SUBDIVISION REVIEW SHEET VARIANCE ONLY

CASE NO.: C8-2016-0187.0A

SUBDIVISION NAME: Mariposa Flats

Variance Request Mariposa Flats Subdivision

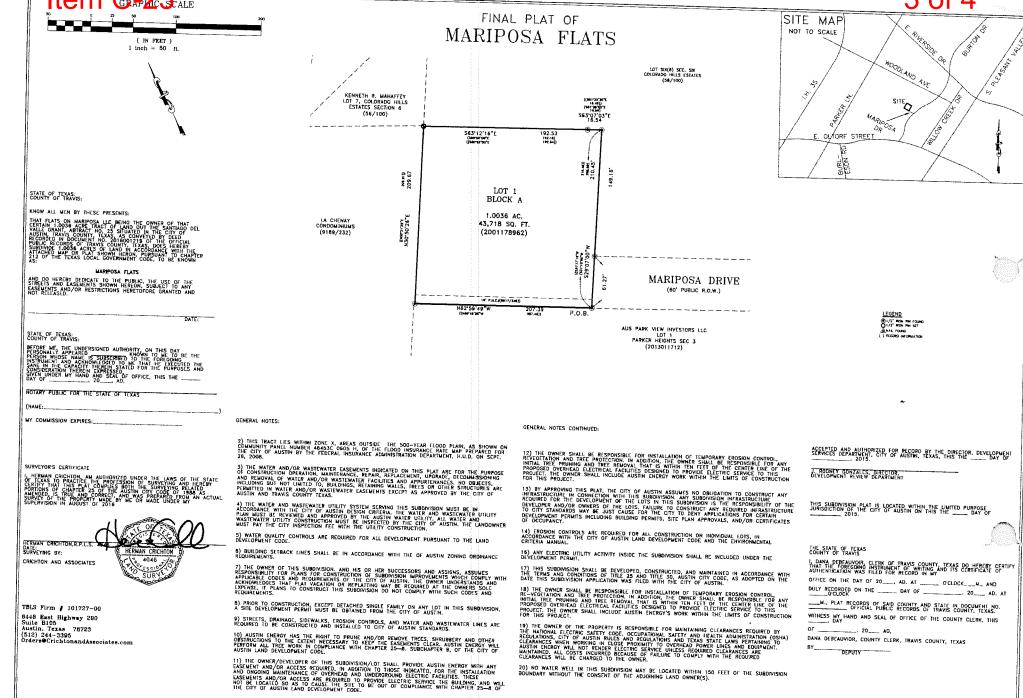
<u>VARIANCES</u>: The applicant requests a variance from LDC Section 25-4-151 which requires that streets in a new subdivision must be in line with existing streets on adjoining property. The applicant proposes to not extend Mariposa Drive through the proposed lot. **Recommended**, (see attached memorandum from Transportation Review).

The applicant for the above referenced subdivision is requesting a variance to Title 25 of the Land Development Code (LDC) Section 25-4-151, which requires streets of a new subdivision to be in line with existing streets on adjoining property. The variance is for the connection to Mariposa Drive.

- Mariposa Drive is an existing local street which provides access to the multi-family units to the north.
- Traffic circulation would not be compromised if Mariposa Drive was not extended because there are other ingress and egress points throughout this subdivision and adjacent subdivisions to right-of-way.
- The proposed development for this subdivision includes a six-story multi-family and parking garage building. The 60-foot right-of-way dedication and setback requirements would reduce the buildable area by approximately 40%. In accordance with the Comprehensive Master Plan, Imagine Austin, staff has agreed to support the proposed multi-family residential development within the Urban Core with the condition to provide pedestrian and bicycle connectivity.

- The site shall provide a 15-foot Sidewalk, Trail, and Recreational Easement along the south property line from Mariposa Lane to the adjacent site to the west.
- An urban trail shall be constructed, in accordance with City of Austin standards, at the time of Site Plan application from Mariposa Drive to the adjacent site to the west.
- This trail connection allows for open and accessible pedestrian and bicycle travel from the
 adjacent multi-family development, and any future adjacent development, to Mariposa Lane
 and bus stops along Burton Drive.
